INNER WEST

DEVELOPMENT ASSESSMENT REPORT

Application No.	MOD/2020/0314	
Address	354 Canterbury Road HURLSTONE PARK NSW 2193	
Proposal	Modification of approved mixed use building including additional level, removal of ground floor business premises tenancy	
Date of Lodgement	16 September 2020	
Applicant	Technik Haus Pty Ltd	
Owner	Mr Aashish A Ali Mr Mustak Shaikh Mr Zaffar Hussain Mr Mustak Shaikh Mrs Preeti Shaikh	Mr Ashfaq G Shaikh Mrs Maniza Shaikh Mr Syedda F Ali Mrs Azharuddin Ali
Number of Submissions	5	
Value of works	\$4,800,000	
Reason for determination at Planning Panel	Modifications to a SEPP 65 affected building	
Main Issues	Permissibility Height of building Floor space ratio Building setbacks	
Recommendation	Refusal	
Attachment A	Reasons for refusal	
Attachment B	Plans of proposed development	
Attachment C	Recommended conditions

Figure 5: Architectural cross section. The upper blue dotted line shows the 13m Height of buildings development standard height plane.

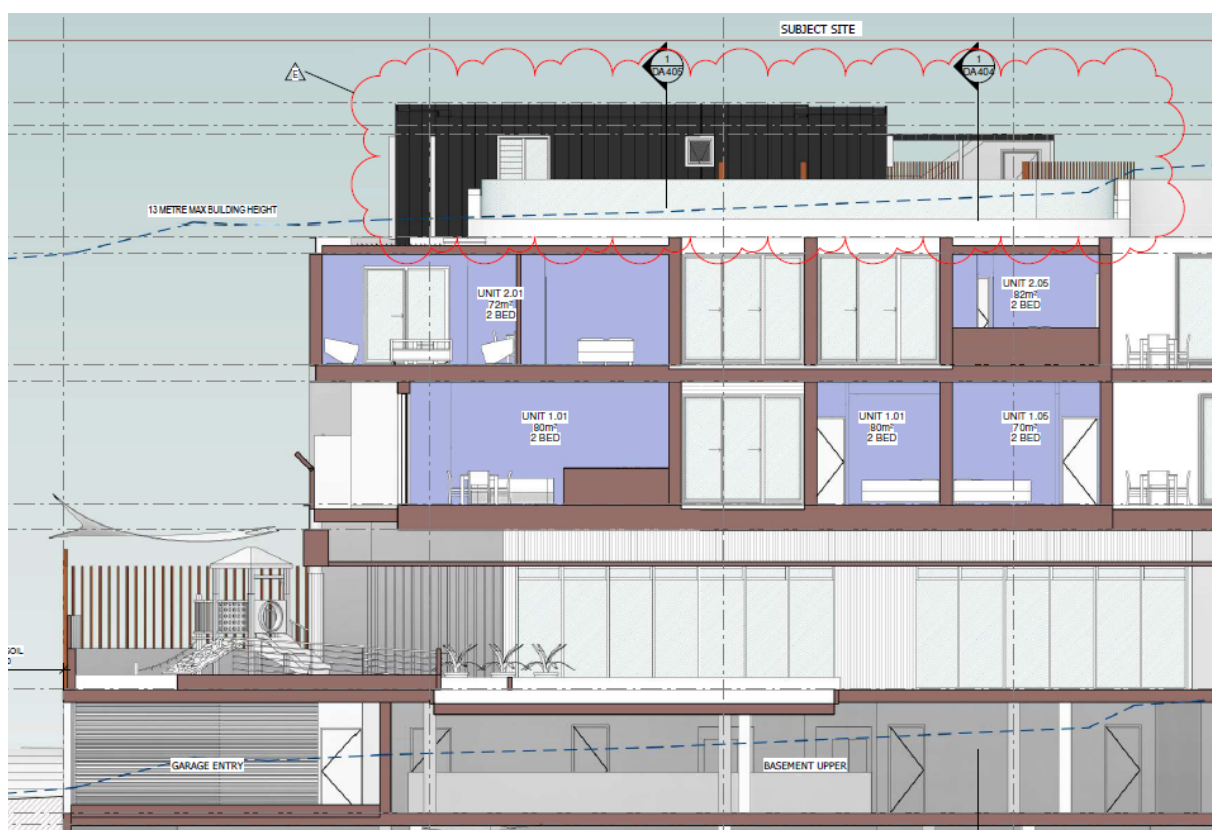
It is noted that the applicant has provided an assessment against the objectives of the development standard and objectives within the supplied Statement of Environmental Effects (SEE). It is also noted that the supplied SEE incorrectly states that the proposed building height is 14.6m (a variation of 1.6m or 12.3%). The provided section clearly shows that the proposed building height is far in excess of 1.6m above the 13m height control (see Figure 5 below).

The proposal results in a variation of the Height of buildings development standard under Clause 4.3 of the LEP by 20.7% or 3m in order to facilitate a new fourth floor.

It is noted that a 1.9m or 13.6% variation to the development standard was approved in the base consent. This variation wholly related to a lift overrun that was centrally located on the roof plane.

Figure 6: Annotated cross section showing balustrade and level of turf.

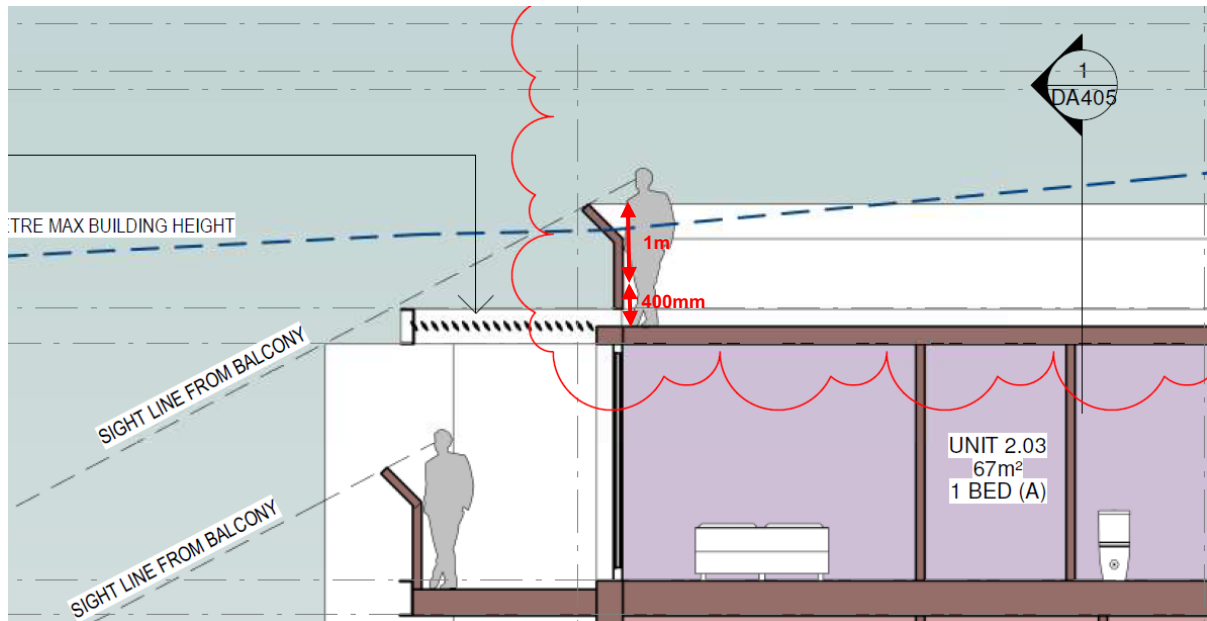
Safety concerns are raised about the revised rooftop communal open space. The perimeter balustrade around the ‘turf area’ is 1400mm above the slab level below (see Figure 6 below), however the landscape plan indicates that this turf area is raised 400mm, thus the vertical portion of the perimeter balustrade has an effective height of less than 1m, contrary to the National Construction Code (NCC).

Figure 7: Map 2 from Chapter D of DCP, red circle denotes subject site.

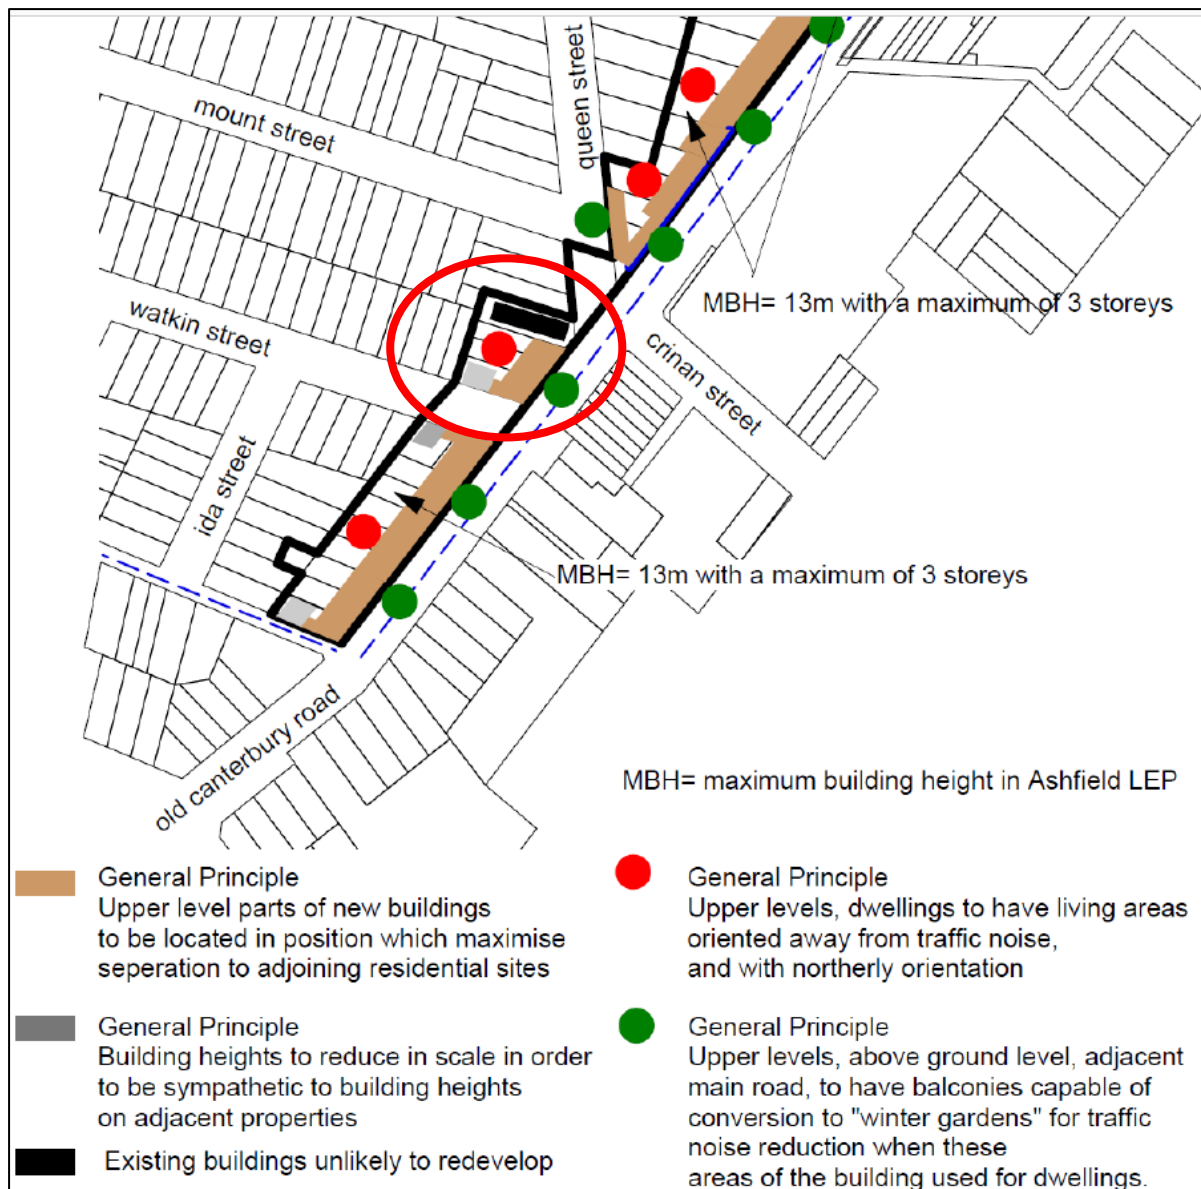
Contrary to DS7.1 and Map 2 (see Figure 7 below), the proposal is 4-storeys in height, in excess of the 3-storey built form control.

Figure 8: Extract of Figure 3 in Chapter D of the DCP.

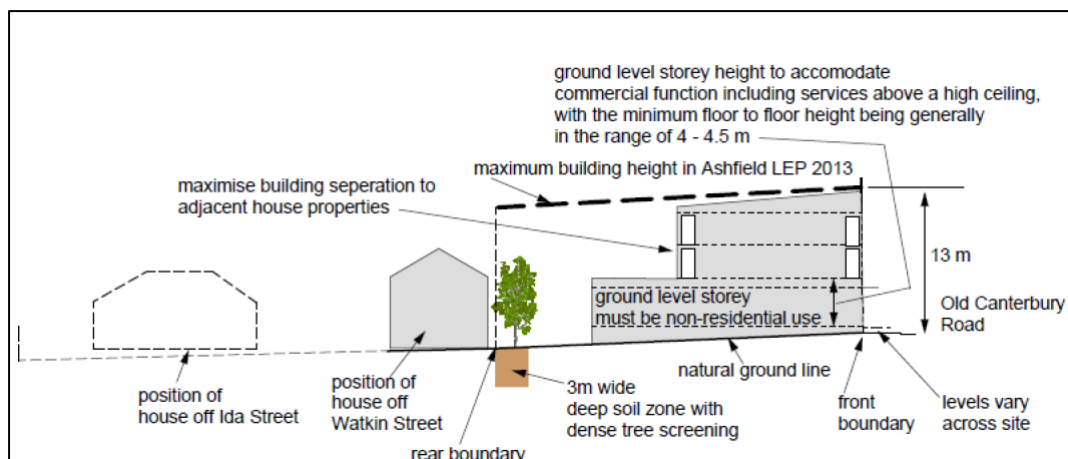
The introduction of a new fourth-floor provides for a poorer transition to the single storey dwelling to the west and is contrary to the built form massing the intent of Figure 3 in Part 7 Chapter D of the DCP (see Figure 8 below).
